POWEREX[®] Product Change Notification

ND, NS, LD, and LS POW-R-BLOK[™] **Manufacturing Location Change to Poland** **# : 2016-015 Rev.: 00**

Date: 2016 / NOV / 04

Example:

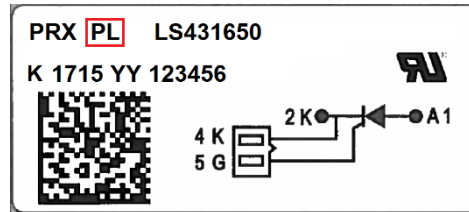
Modules assembled in Poland will contain the country code letters "PL" following the "PRX" logo.
